Access Compliance Report

Public Rights-of-Way

(Curb Ramps)

Intersection ID: 32204	Main Street: LANCKEN_DR	Cross Street: PROVINCETOWNE_DR	Location: NW
ADA ID: 3A7097007A8D	Ramp Type: PerpDiag	Initial Pass/Fail: Pass	Overall Compliance: No
		Severity Score: 17.5

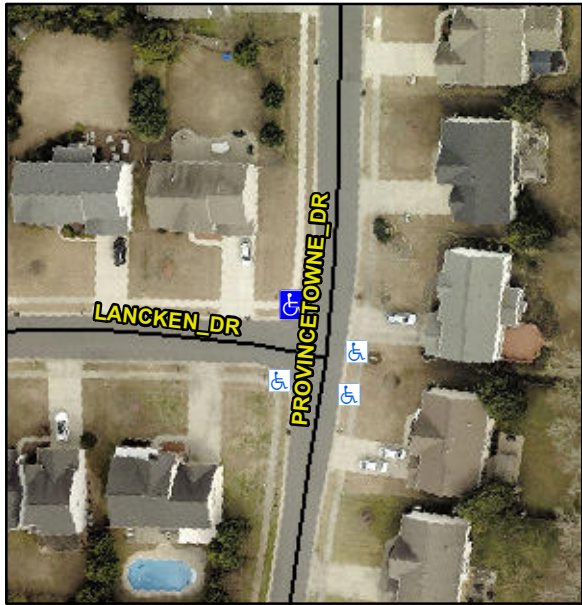
Codes/Mitigation Info/Possible Solution			Field Measurements/Component Compliance					
	Possible Solutions:		Compliance	Description	Data	Compliance	Description	Data
	Remove & Replace Curb Ramp With Two New Directional Ramps or Equivalent.		N/A	Ramp Length (in)	46.0	Yes	Ramp Slope (%)	7.4
			Yes	Ramp Width (in)	96.0	Yes	Ramp XSlope (%)	0.1
			N/A	Flare Type LT	Sloped	N/A	Flare Type RT	N/A
			N/A	Flare Slope LT (%)	2.7	N/A	Flare Slope RT (%)	2.2
			N/A	Flare Traversable LT?	No	N/A	Flare Traversable RT?	No
			Yes	Landing Length (in)	48.0	No	DWS Provided?	No
			Yes	Landing Width (in)	96.0	N/A	DWS Contrast?	No
			Yes	Landing Slope (%)	0.3	N/A	DWS Length (in)	N/A
			Yes	Landing X Slope (%)	0.1	N/A	DWS Full Width?	No
Surveyor Notes:		N/A	N/A	Landing Curb? (Y/N)	No	N/A	DWS Offset (in)	N/A
PROW/ADA:		Not Found, R305, R302.7.2	N/A	Shared Landing?	No			
			Yes	Gutter Ponding?	No	Yes	Gutter Slope (%)	0.4
			No	Gutter Lip Ht (in)	0.5	Yes	Gutter X Slope (%)	0.8

N/A	Painted X Walk1?	No	N/A	Painted X Walk2?	No
				X Walk 1 Direction	To SE		X Walk 2 Direction	To SW
			N/A	X Walk 1 Width (in)	N/A	N/A	X Walk 2 Width (in)	N/A
				X Walk 1 Slope (%)	0.7		X Walk 2 Slope (%)	1.9
				X Walk 1 X Slope (%)	0.1		X Walk 2 X Slope (%)	1.0
			N/A	Ramp inside XWalk1?	N/A	N/A	Ramp inside XWalk2?	N/A
				Road Slope (%)	0.8	N/A	Clear Space?	Yes
				Road X Slope (%)	0.5	N/A	Clear Space to XWalk (in)	N/A
			Yes	Any Obstructions?	No	Yes	Storm Grate/Utility Hazard?	No
				Obstruction Type			Storm Grate/Utility Type	
					N/A			N/A
						Yes	Surface Condition? (G/P)	Good
Total Cost:		\$ 3200.00
